BARANOF INTERBAY STORAGE

DRB Recommendation Presentation #3

Meeting Date 10/19/2016
SDCI PROJECT # 3022095

2.0 REC BOARD COMMENTS + ITEMIZED RESPONSES

SITE LIGHTING - WITH STREET LIGHTING

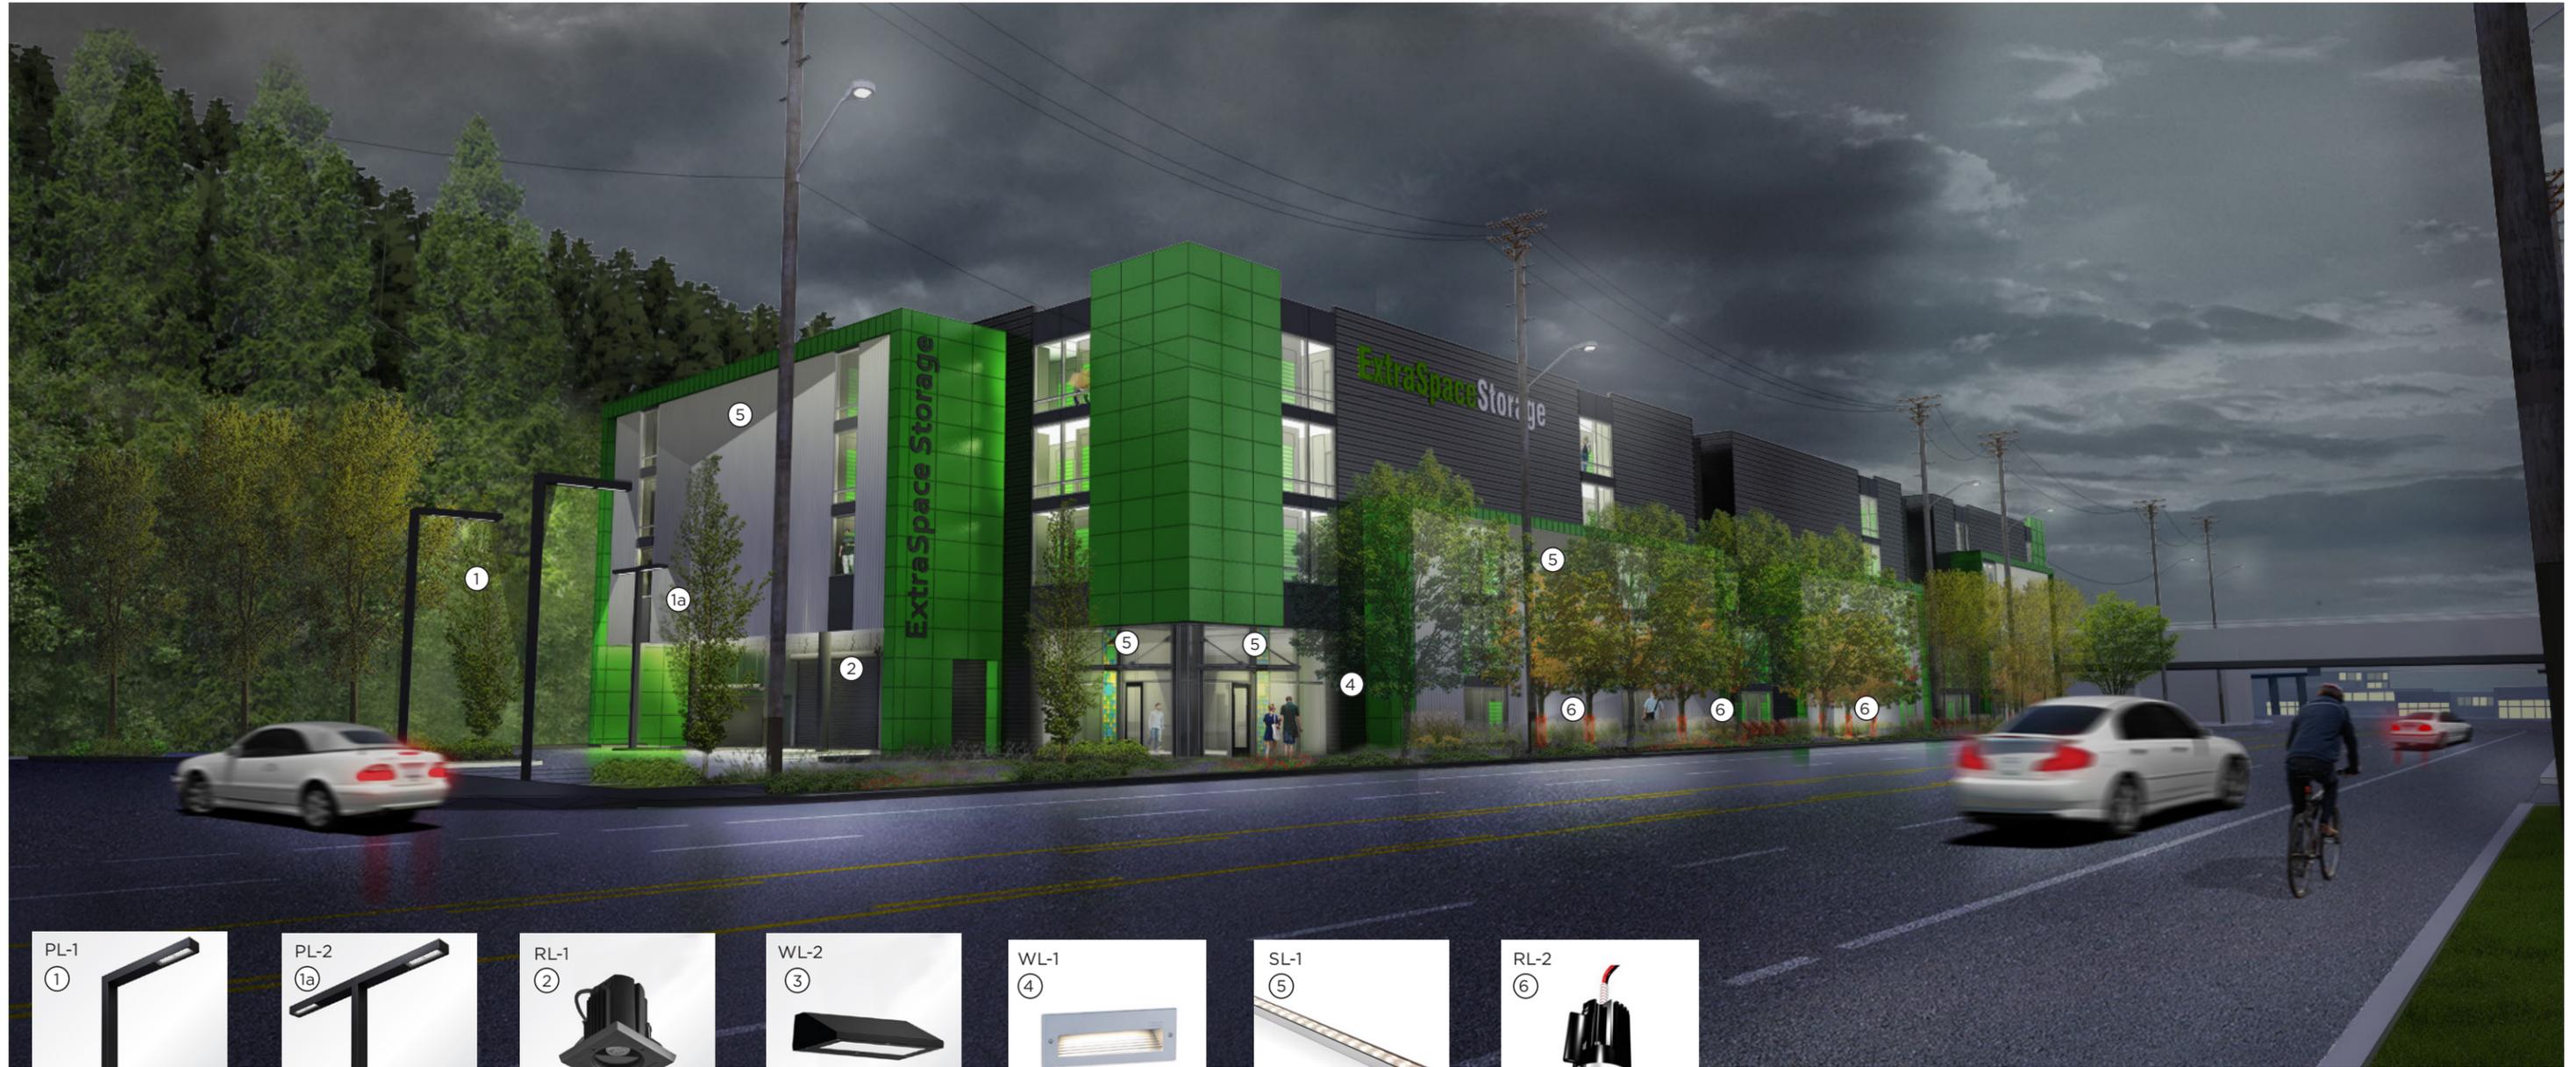
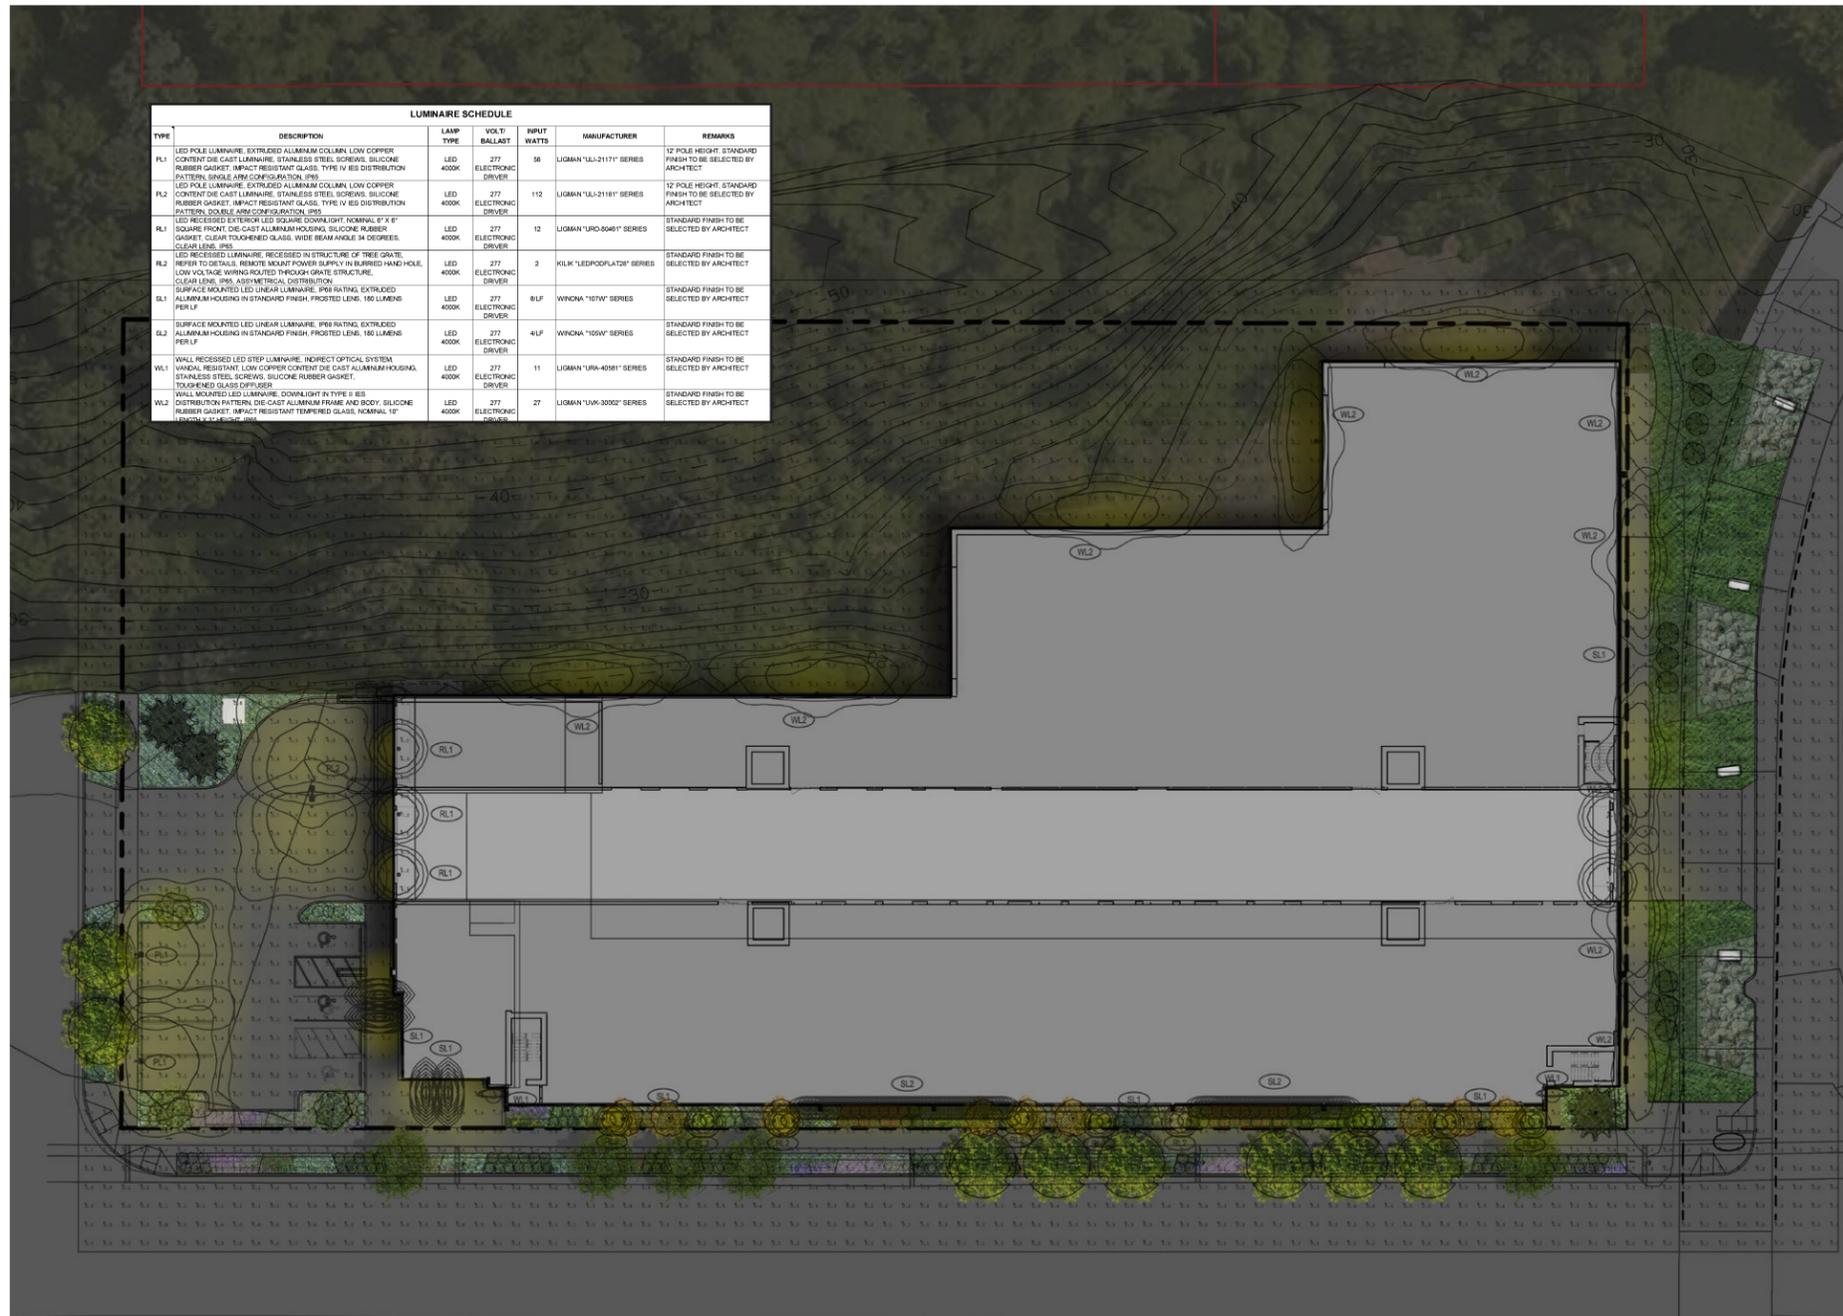
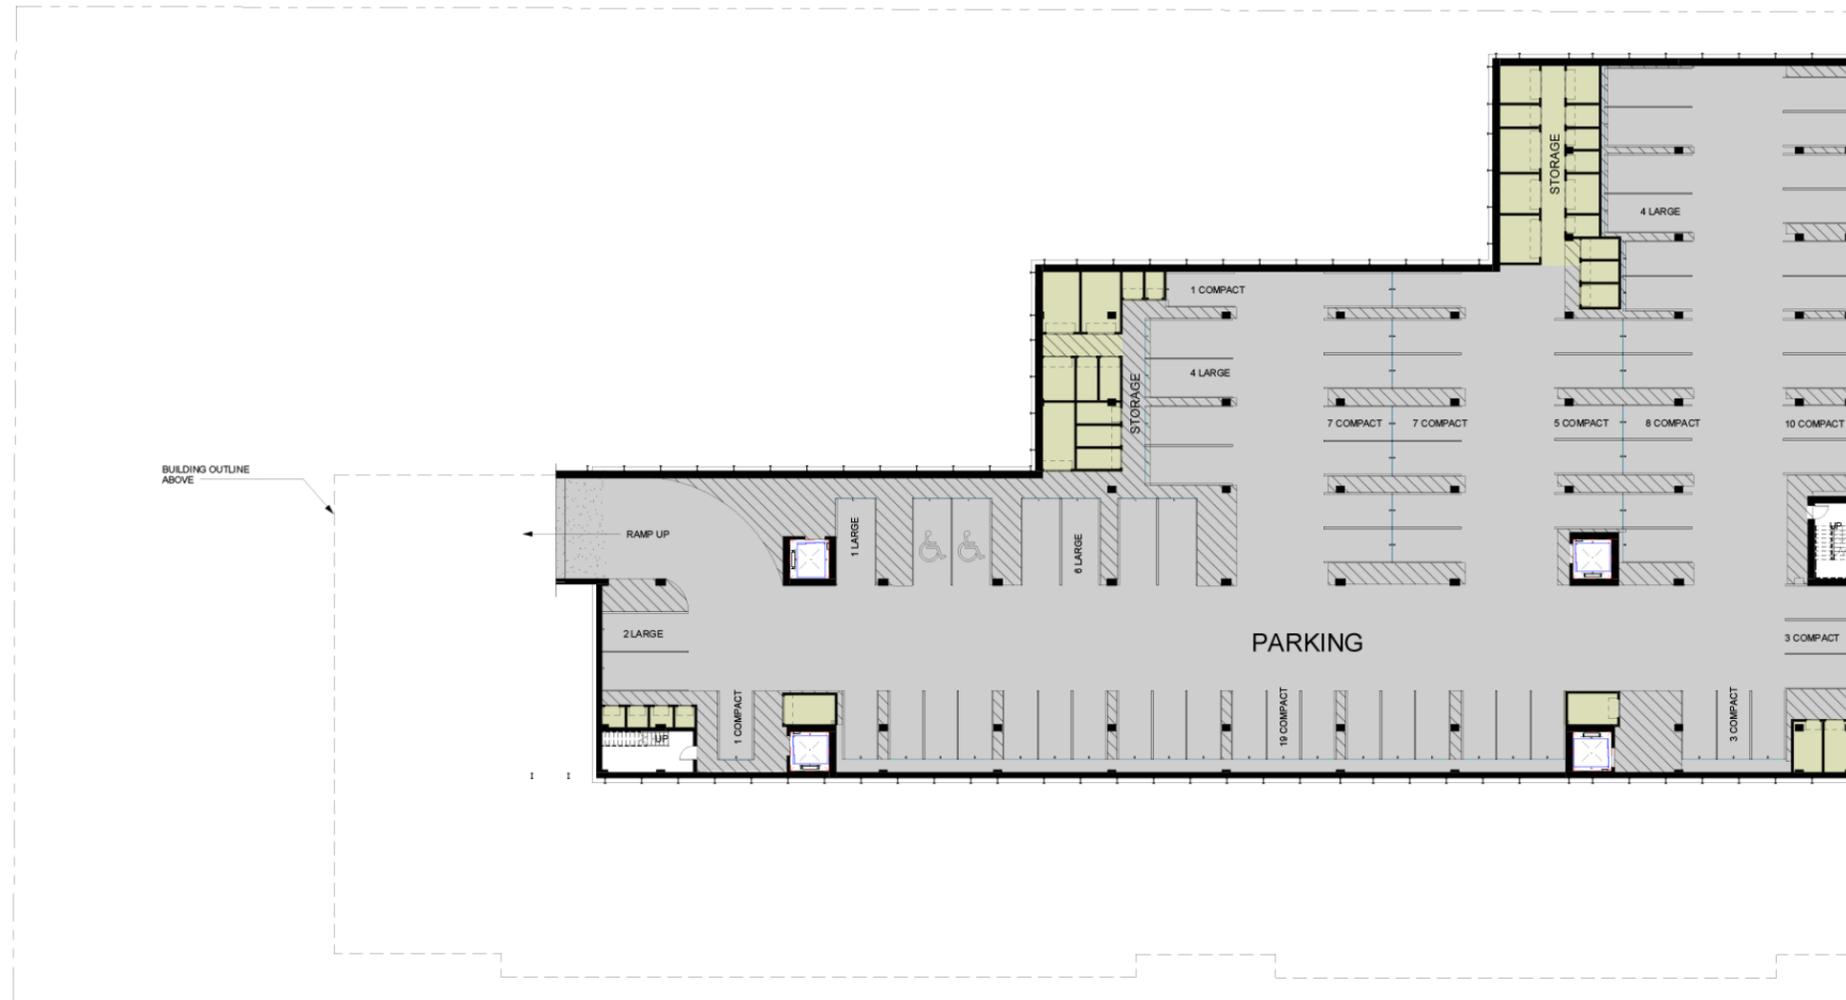
a. The Board was comfortable with the LED lighting, but would welcome landscape lighting as well to highlight plantings and provide human scale lighting.

Additional lighting has been added to the tree guards to provide highlights along the 25th avenue elevation in addition to the general illumination provided by the LED building lights.
